CLEVELAND NATIONAL FOREST POWER LINE REPLACEMENT PROJECTS

MINOR PROJECT REFINEMENT REQUEST FORM

**Cleveland National Forest Power Line Replacement Projects
Minor Project Refinement Request #27
Attachment B: Photographs**

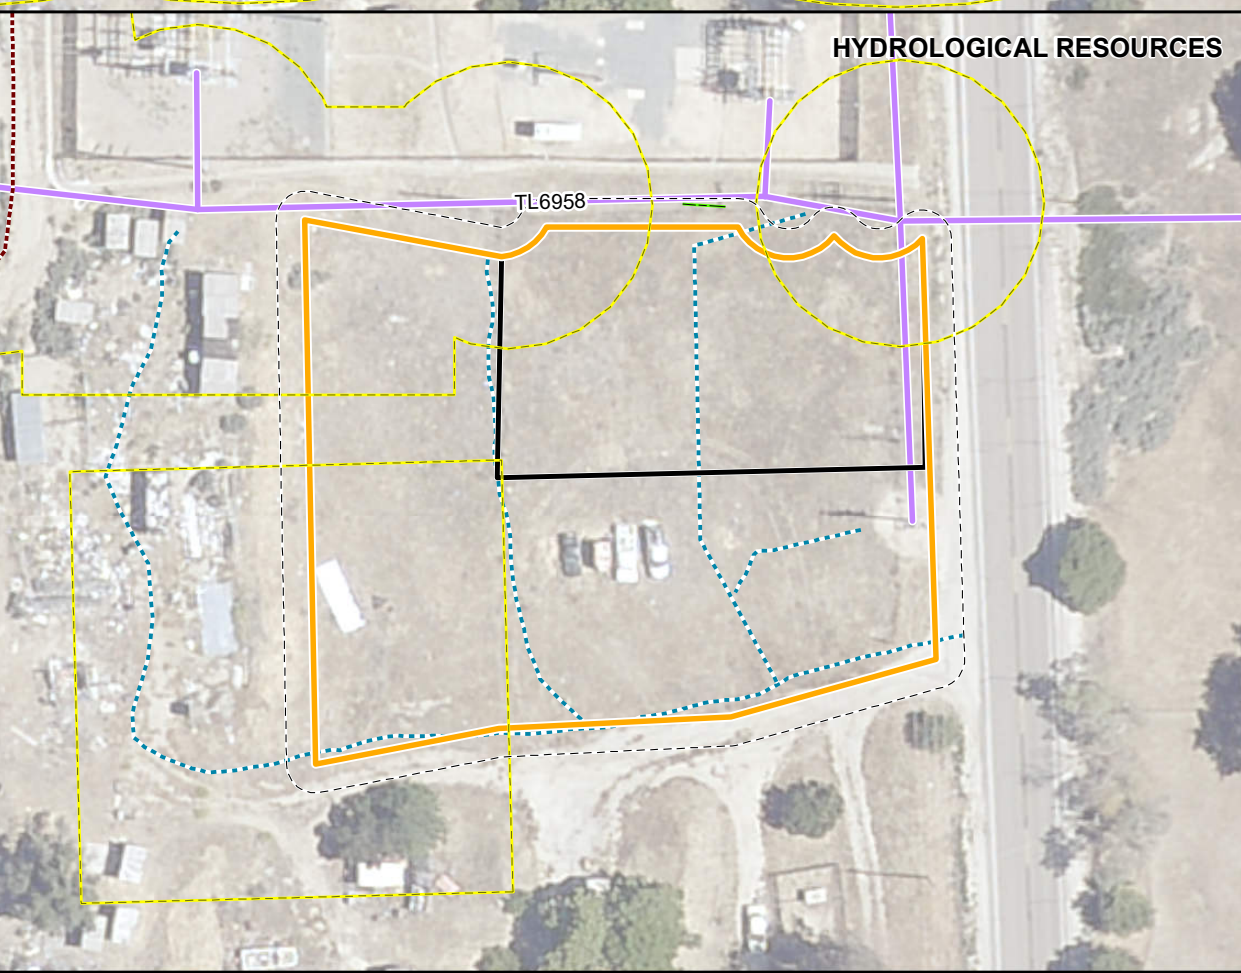
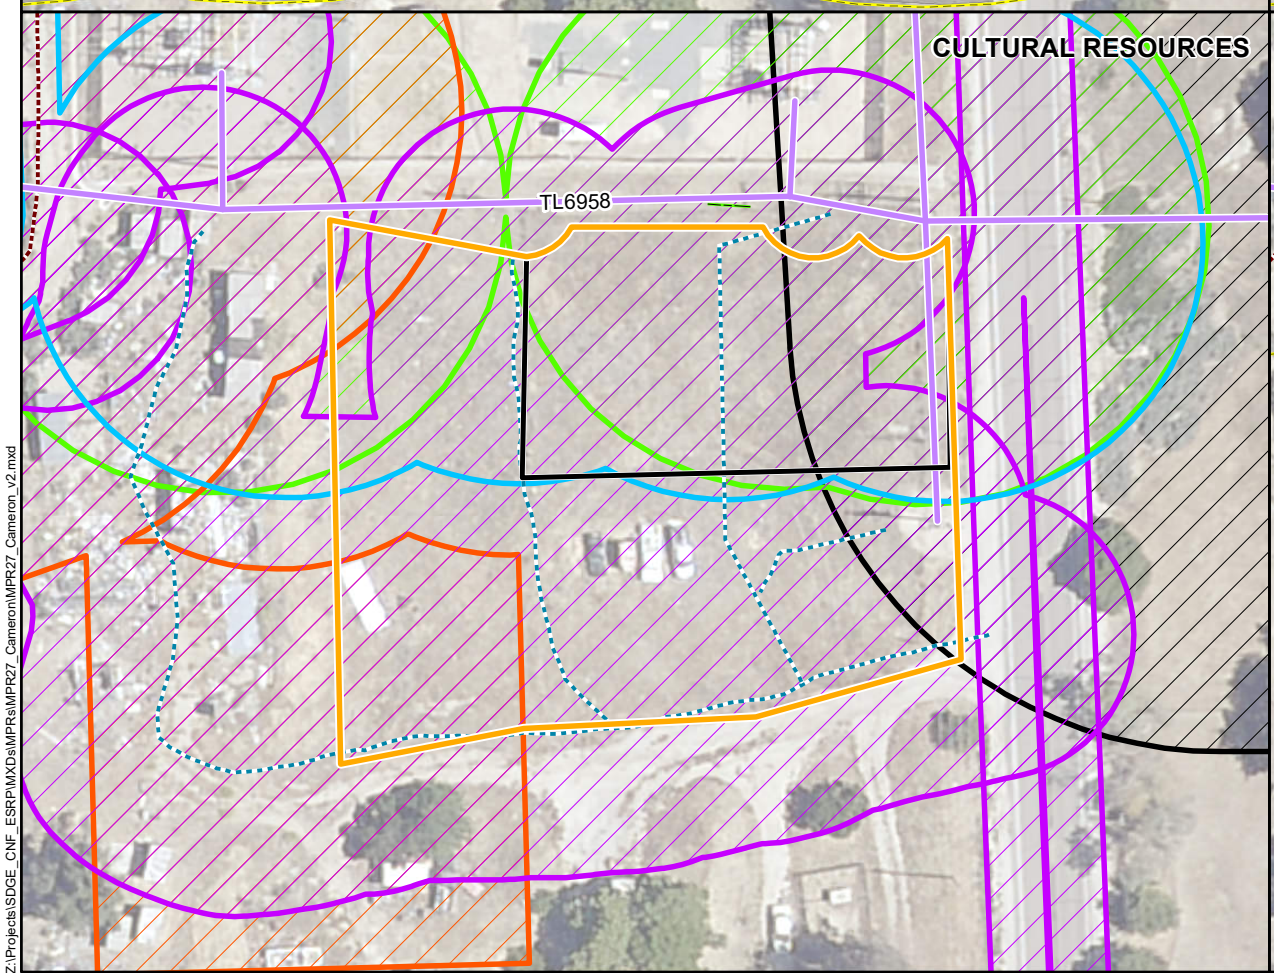
Photograph 1:
Northwest-facing view of the requested Cameron Staging Yard and the existing approved access road, as observed on November 2, 2018. All vehicles and debris will be removed by the property owner prior to development of the yard.

Photograph 2:
Northeast-facing view of the requested Cameron Staging Yard, as observed on November 2, 2018.

**Attachment C: Survey Area Map
Map 1 of 1**

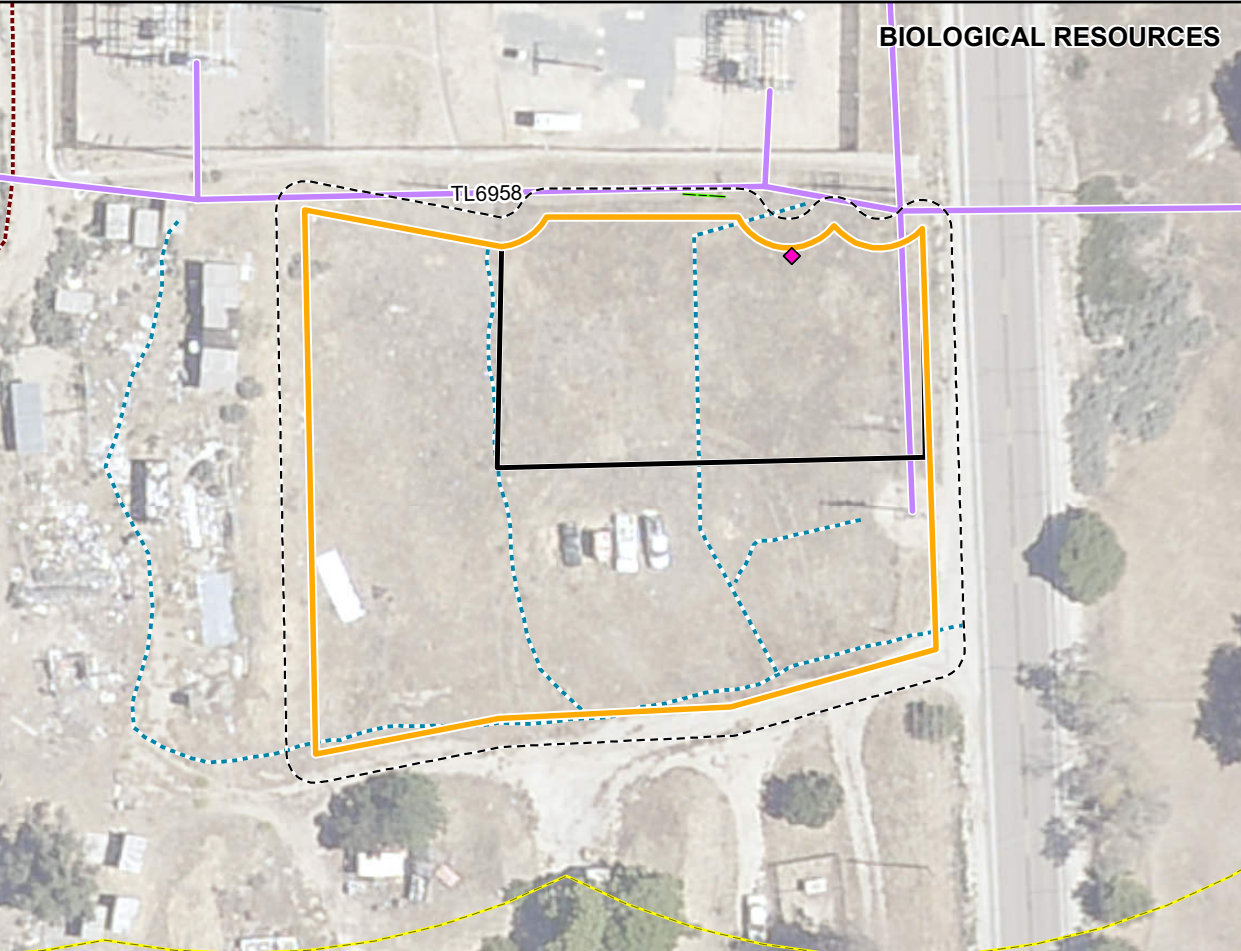
(d) Does the proposed refinement trigger an additional permit requirement?		<input type="checkbox"/> Yes	<input checked="" type="checkbox"/> No	
Describe refinement being requested (attach drawings and photos as needed):				
As depicted in Attachment B: Photographs and Attachment C: Survey Area Map, SDG&E requests to enlarge the baseline Cameron Staging Yard from approximately 0.27 acre to approximately 0.82 acre. This change will result in an increase of approximately 0.52 acre of temporary impacts ² to disturbed (ruderal/barren) habitat. Minor grading and vegetation removal will be required for yard utilization and fire-prevention maintenance. Old vehicles and debris are present in the refinement area, but the property owner will be removing them prior to development of the yard. The refinement area will be accessed via an existing dirt construction-only access road that was approved in Notice to Proceed #19/MPR #22 for Transmission Line (TL) 6958, and is anticipated to be used for approximately 18 months in support of construction on TL6958 and TL6923. The activities associated with the utilization of the refinement area will be consistent with the project description provided in the Final EIR/EIS for staging yards.

Provide need for refinement (attach drawings and photos as needed):				
The Cameron Staging Yard was approved as part of the 2015 baseline data; however, during the Notice to Proceed (NTP) phase of TL6958, SDG&E's construction contractor had not finalized the necessary footprint and use of this yard, so it was left out of NTP request #19. The construction contractor has since submitted the finalized footprint and intended uses of this yard. The construction contractor is requesting to enlarge the yard footprint to accommodate storage for the purchase/delivery of poles. Due to the delay in the construction schedule and because poles are remaining in yards longer than anticipated as they are not being installed on schedule, additional room is needed to accommodate storage of the poles/materials that will be used for construction on TL6958 and TL6923. Additionally, this yard is adjacent to the Cameron Substation (southern terminus of TL6958) and will provide additional workspace needed for overhead and underground work associated with the transmission and distribution tie-ins to the substation. The yard will also provide additional workspace for crews to assemble and frame steel poles and transport the poles to work sites located in the southern vicinity of TL6958 and the eastern vicinity of TL6923; thereby, reducing hauling limitations and the need for additional workspaces for framing poles along the right-of-way.
